COMMENT REPORT

CASE NUMBER: C814-2021-0099

PROJECT NAME: Brodie Oaks Redevelopment

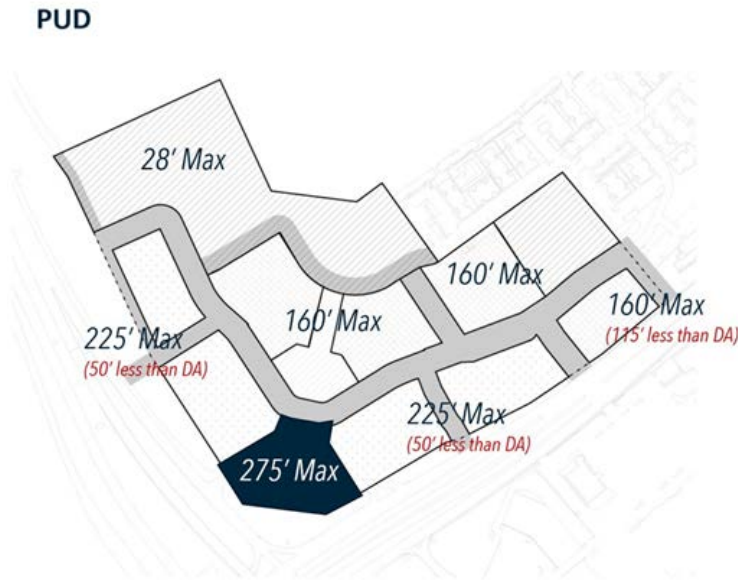
- CA 6. Exhibit G – Grading. Thank you for this exhibit and information. Staff was not able to review for potential impacts to trees as originally requested as there was no tree legend with tree numbers, size, and species included to correspond with the tree circles shown on the exhibit. Please provide this additional information to allow for review at this time.

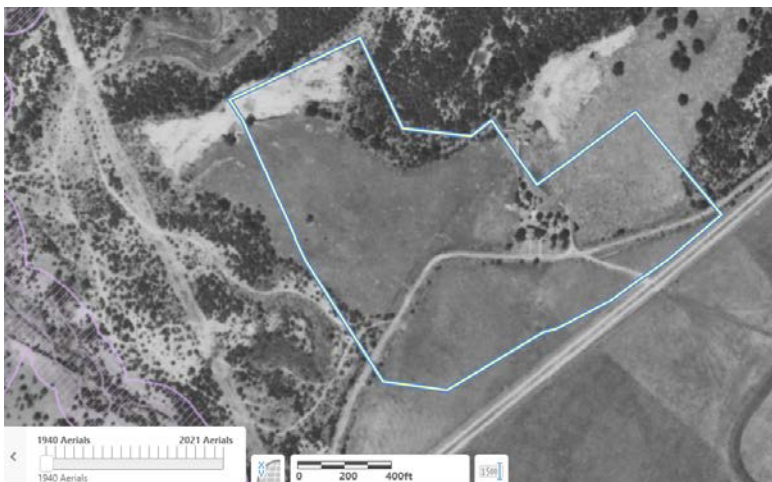
- EV2. *Exhibit C: Land Use Plan.* Remove the note on sh. 4 stating, “Chapter 25-2 Article 11 Hill Country Roadway Overlay Requirements shall not apply to any portion of Land Use Area 1.” Proposed modifications to Hill Country Overlay requirements are proposed to be made strategically to individual provisions, not as a blanket rejection of an entire section of code.

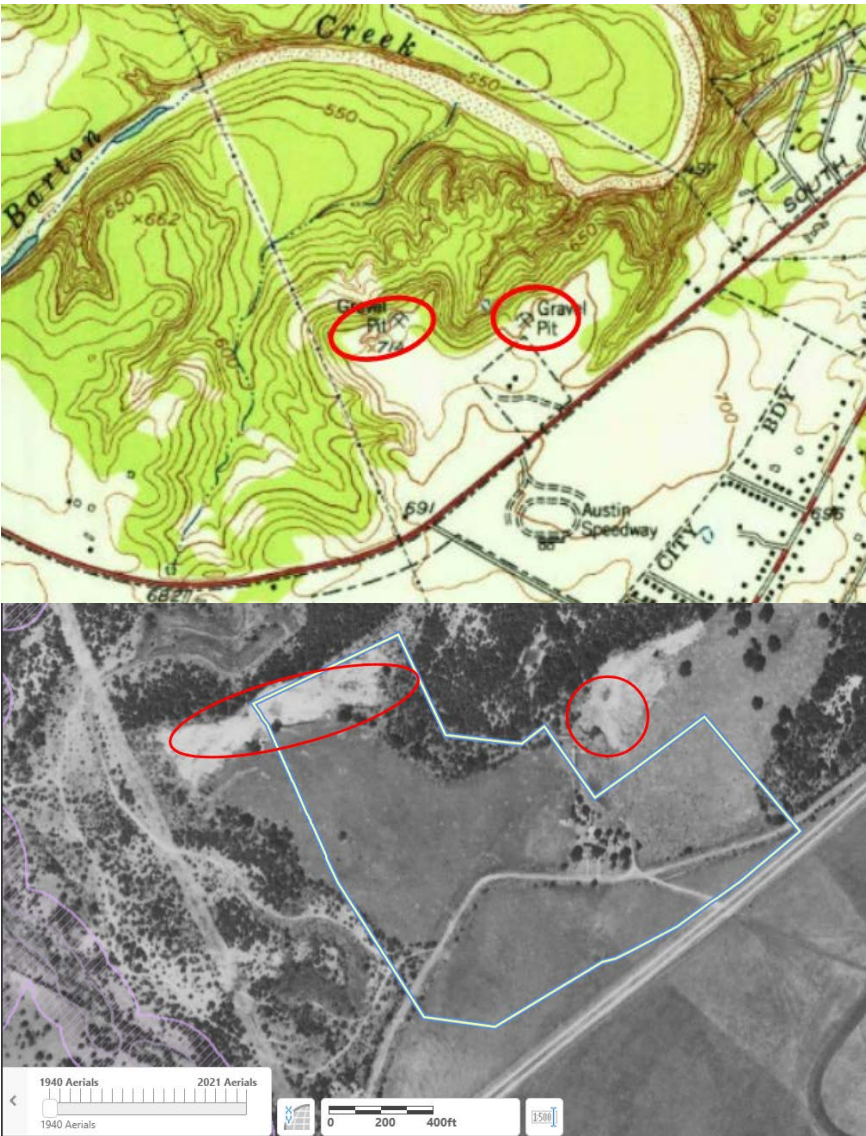
- EV6. 25-8-341/342. If the development “is proposing to restore the site back to original pre-development grades,” modifications to 25-8-341 & 342 may not be necessary. Grading is measured from the original elevation, so returning the site to original grades will require less rather than more grading. Please do more research to get a better idea of the pre-development elevations. The image below is from 1940 and is available on Property Profile. The topo was provided by the previous reviewer.

Also, it looks to me as if the two gravel pit areas shown on the topographic map (1955?) are outside of the areas where grading is proposed with this project.

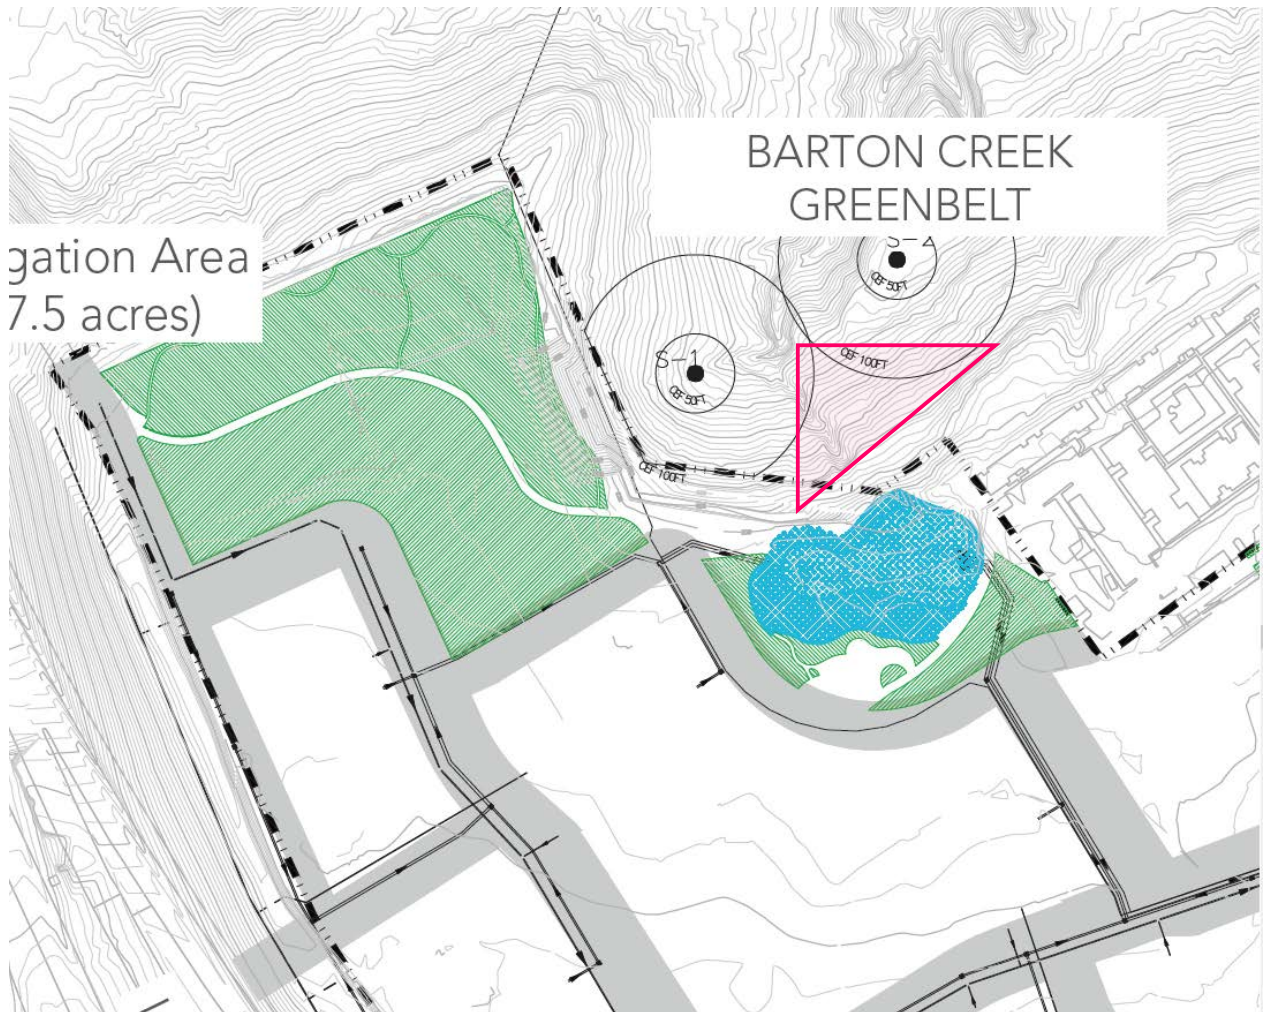
- HG 4. Only include the standard 150-foot setback for all CEFs. Remove 50-foot setback label.
- HG 5. Please calculate area of reduction for setback S-1 (orange) and incorporate into the buffers on the upslope side between S1 and S2 (pink). See picture below for additional clarification
